TECHNICAL MEMORANDUM
UPPER AQUIFER INVESTIGATION
MONITORING WELL AND SAMPLING
PROPOSAL
(REVISED MAY 3, 1996)

AMERICAN CHEMICAL SERVICE, INC.
NPL SITE
GRIFFITH, INDIANA

May 3, 1996

Re: Upper Aquifer Investigation Technical Memorandum
Response to Disapproval and Comments

FIGURE 1

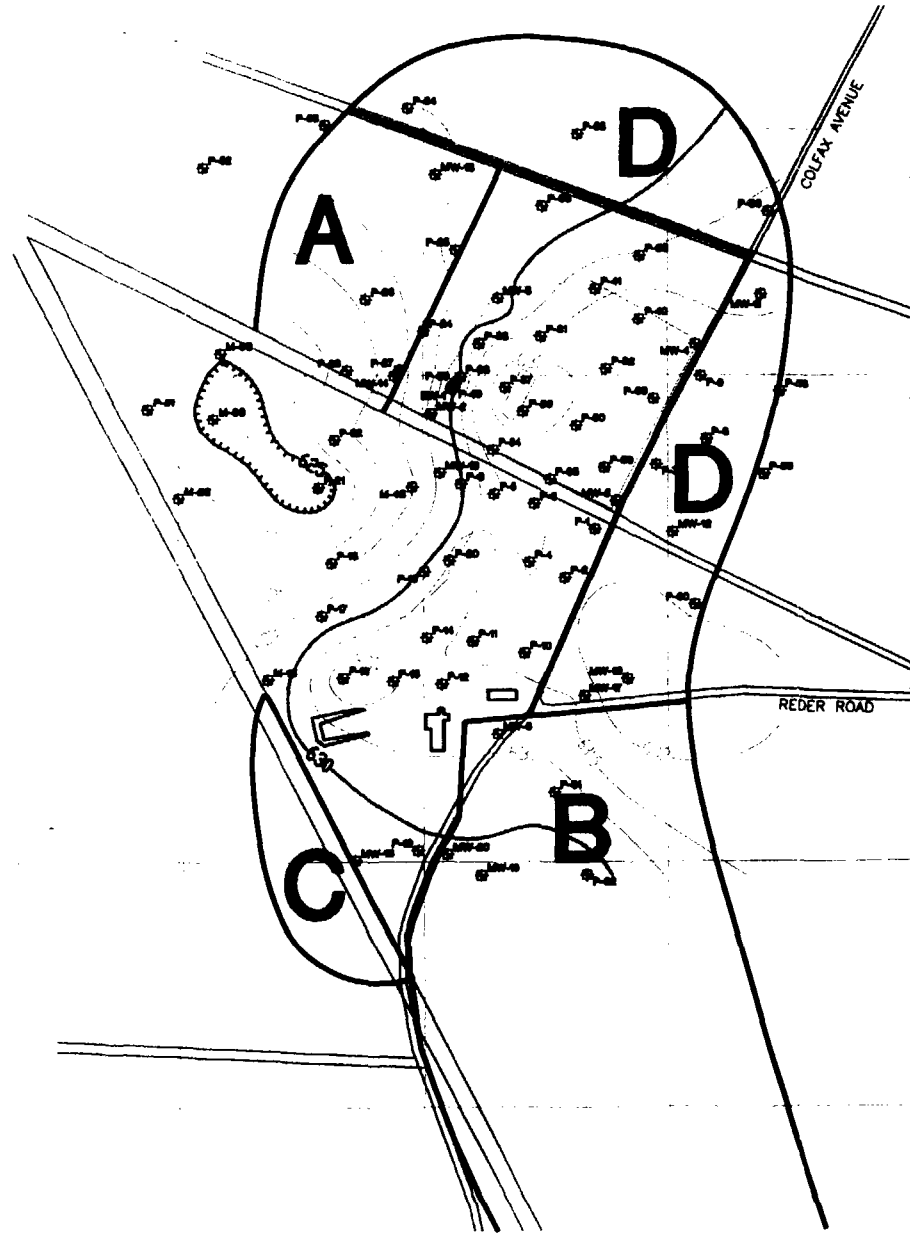
10. **Page 1, 2nd paragraph.** The boundaries of bulleted areas A,B,C and D described in this paragraph are not clear. Present the boundaries of these areas on Figure 1.

11. **Page 2, 3rd paragraph.** Present the location of MW-9 on Figure 1.

30. Table 1. Include all wells on Figure 1. For instance, MW 10C is not shown and should be included.

Areas A, B,C, and D were selected in the SOW to represent general areas that should be investigated with specific procedures. The areas are general and so the representation in Figure 1 is general. The letters A, B, C, and D are clearly marked and discussed in the text. No modifications to Figure 1 are necessary.

Figure 1 includes the upper aquifer monitoring wells and piezometers. Monitoring Well MW-9 is screened in the lower aquifer. Therefore it, along with the other lower aquifer wells, was not included on Figure 1.

The subject of this Technical Memorandum is the upper aquifer. Monitoring Well MW-10C is not an upper aquifer monitoring well, therefore, it is not included on Figure 1.

FIGURE 2

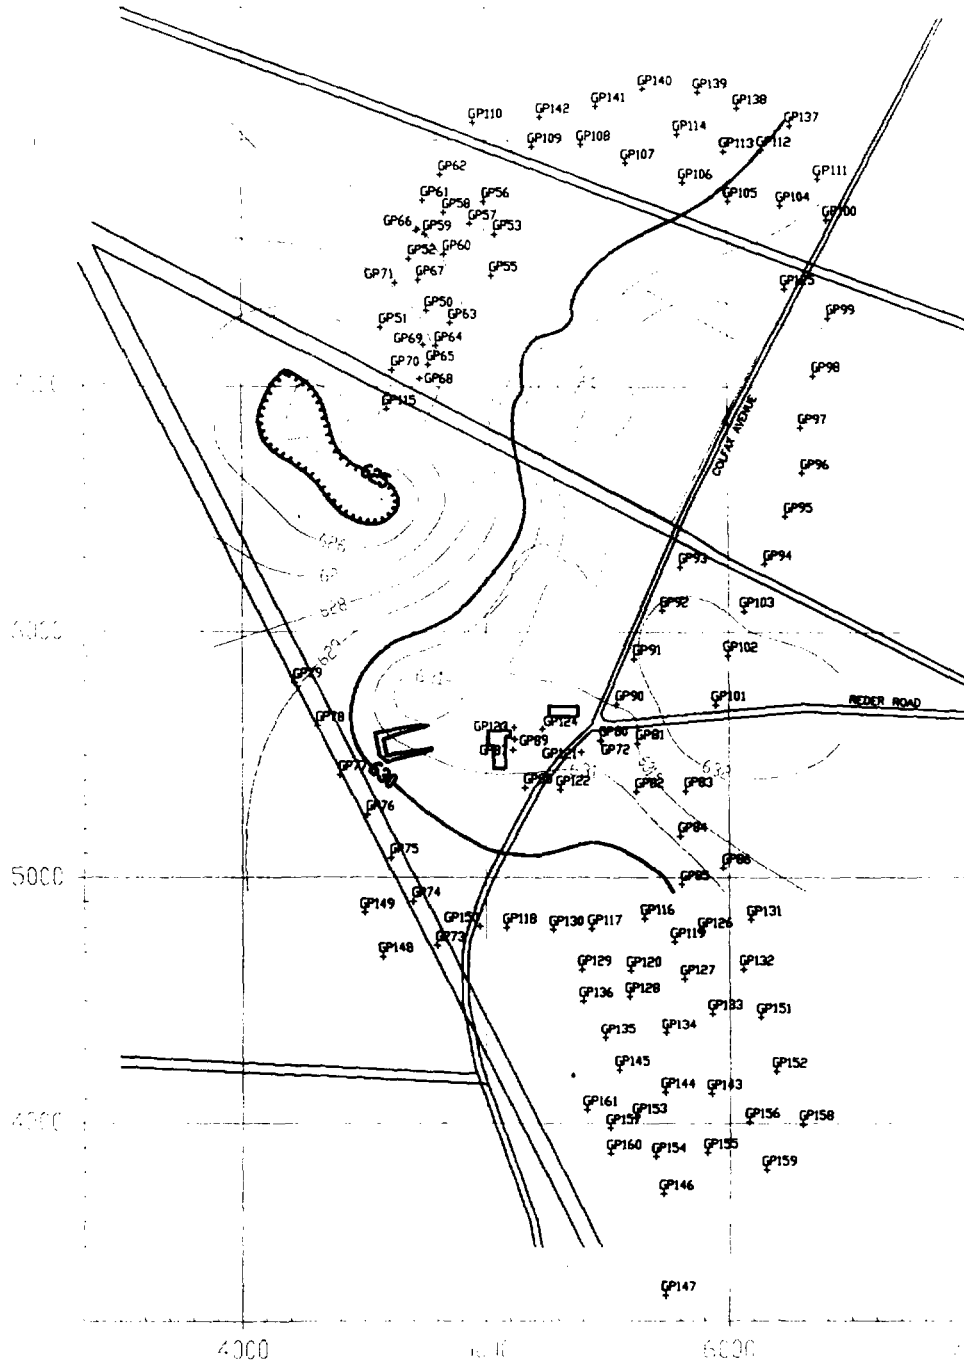
28. Page 11, last paragraph. This states that "One surface water sample was collected near P-61 north of the ACS facility (Figure 2)." The report previously states that the sample collected near piezometer P-63, and Figure 2 does not illustrate the location of the surface water sample. This needs to be corrected.

29. Page 11, Surface Water Samples. The surface water sample location was not plotted on the map. The surface water sample appears to have been collected near P-63, rather than P-61. Include the sampling location and ditch on figure 2.

The text of has been corrected in the revised Technical Memorandum.

FIGURE 6

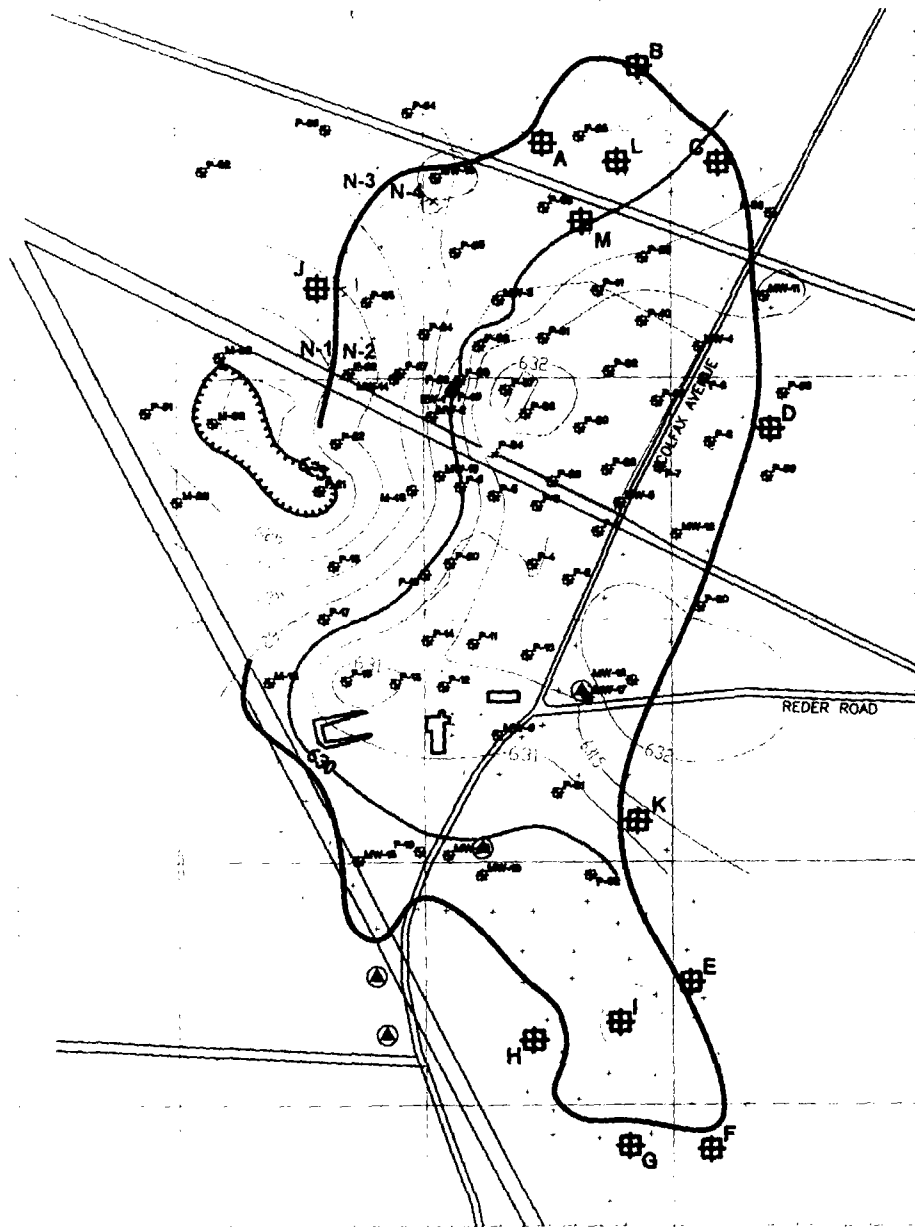
Two wells are recommended (a cluster at each location) along the inferred plume axis, in addition to the well locations already shown. One monitoring well is suggested approximately 150 feet northeast of P-62, to provide adequate monitoring coverage of this area. An additional monitoring well is suggested approximately 500 feet south of P-62, to better define the nature of contamination within this area.

ii) Several shallow well clusters are anticipated along Colfax Avenue. A monitoring well is suggested between P-58 and P-59 just outside the line where benzene was detected, as specified on figure 5. This well will provide coverage of the area between MW-11 and MW-12, which are over 1000 feet apart. A monitoring well is suggested near P-63 to better define the nature of contamination in this area.

However, as directed by the U.S. EPA in the April 29, 1996 clarification letter, the text of the Technical Memorandum has been modified to include piezometers in sets of two, at four locations. These are shown on Figure 6 as N-1, N-2, N3, and N-4.

However, at the insistence of U.S. EPA, a well is proposed for installation at this location. It is labeled "J" on Figure 6 of the revised Technical Memorandum.

At the meeting with U.S. EPA and IDEM on April 23, 1996, the ACS Technical committee agreed to install an additional well interior to the plume extending southeast from the site. It is discussed on page 10 of the revised Technical Memorandum and it is labeled "I" on Figure 6

An additional upper aquifer monitoring well in the northern area of the plume was agreed to at the April 23, 1996 with U.S. EPA and IDEM. It is indicated by the symbol and letter "C" on Figure 6 of the revised Technical Memorandum.

At the insistence of U.S. EPA, two additional wells have been added to the upper aquifer investigation inside the contaminant plume zone north of the ACS facility. These are indicated by the symbols and letters "L" and "M" on Figure 6 in the revised Upper Aquifer Technical Memorandum.

During the discussion with U.S. EPA and IDEM on April 23, 1996, the ACS Technical Committee agreed to place an additional upper aquifer monitoring well at the location discussed above. It is indicated by the symbol and letter "D" on Figure 6 in the revised Upper Aquifer Technical Memorandum.
